Project	IEEE 802.16 Broadband Wireless Access Working Group < http://ieee802.org/16 >	
Title	Amendment to section 14.2.5.2.1.1	
Date Submitted	2007-01-12	
Source(s)	Peretz Feder - ALU	pfeder@alcatel-lucent.com ,
	Honghai Zhang – ALU	hozhang@alcatel-lucent.com
	Philp Barber - Huawei	pbarber@huawei.com
Re:		
Abstract	Additional Hand over primitives	
Purpose	Adoption	
Notice	This document has been prepared to assist IEEE 802.16. It is offered as a basis for discussion and is not binding on the contributing individual(s) or organization(s). The material in this document is subject to change in form and content after further study. The contributor(s) reserve(s) the right to add, amend or withdraw material contained herein.	
Release	The contributor grants a free, irrevocable license to the IEEE to incorporate material contained in this contribution, and any modifications thereof, in the creation of an IEEE Standards publication; to copyright in the IEEE's name any IEEE Standards publication even though it may include portions of this contribution; and at the IEEE's sole discretion to permit others to reproduce in whole or in part the resulting IEEE Standards publication. The contributor

Figure xxx – Primitive flow between NCMS at the MS and the MS when HO is initiated

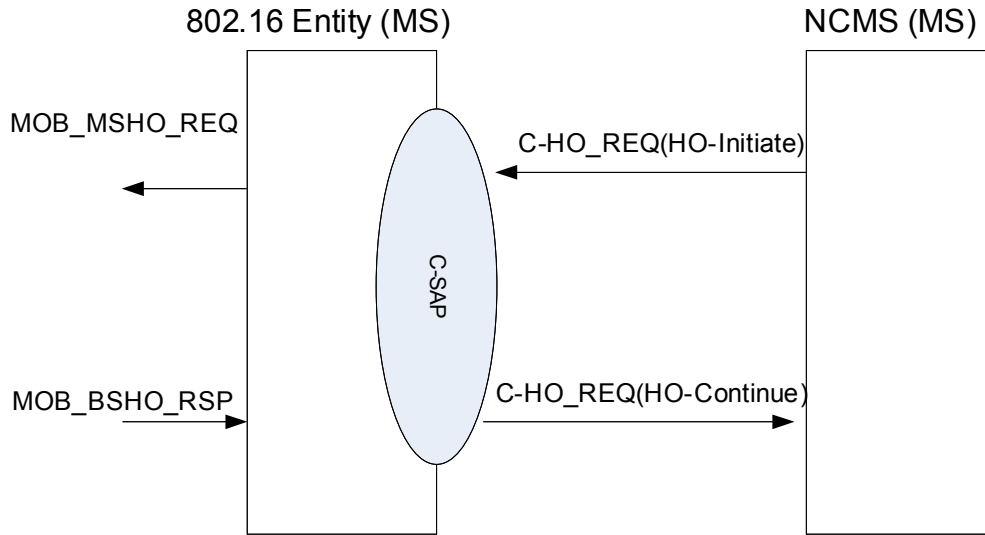
8 The 802.16g draft is missing the trigger for Mobile Initiated Handover. When the NCMS
9 at the MS decides to initiate a handover (as opposed to HO-Start) with the Serving BS it
10 informs the 802.16 MS entity to send a MOB_MSHO-REQ listing the candidate BS for
11 an upcoming HO-Start or HO-Cancel.

19 14.2.5.2.1.4 C-HO-REQ (Action_Type==HO-Initiate)

21 This primitive is used by the Mobility Management Services entity in the NCMS at the MS side to indicate the
22 initiation of the HO process. In case of SHO/FBSS, it can be used to update Anchor BS or to add a new Active
23 BS to the current Active set. The NCMS in the MS can use this primitive to inform the 802.16 MS entity to
24 initiate the HO process and inform the serving BS of all the candidate BSs for HO as seen by the MS.

51 **14.2.5.2.1.5 C-HO-REQ (Action_Type==HO-Continue)**

1 This primitive is used by the MS to inform the Mobility Management Services entity in the NCMS MS about the
 2 arrival of a MOB-BSHO_RSP MAC message in response to the previously generated MOB_MSHO-REQ
 3 message and the pruned down list of the candidate BSs selected by the Mobility Management in the NCMS for
 4 the upcoming actual HO phase.
